SERVICE BULLETIN

Service Bulletin No.: 2016-0006

Amerivan Dodge/Chrysler

Power Door Add - Program 4.00 requires 4 wiring changes in the black plug on the controller harness.

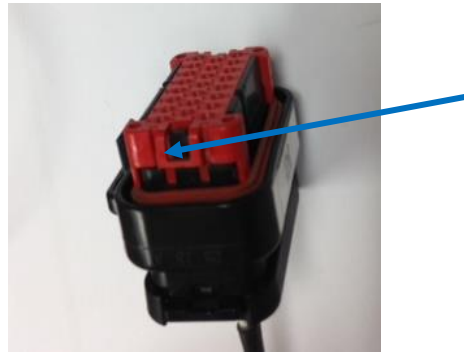
Step 3: Reposition the following 4 wires in the black plug

- Pin 2, Yellow wire labeled “Door Ajar SW” needs moved to pin location 3
- Pin 3, White wire labeled “H-E Signal B” needs moved to pin location 2
- Pin 8, Yellow wire labeled “Stow SW” needs moved to pin location 9
- Pin 9, Yellow wire labeled “Handle SW” need moved to pin location 8
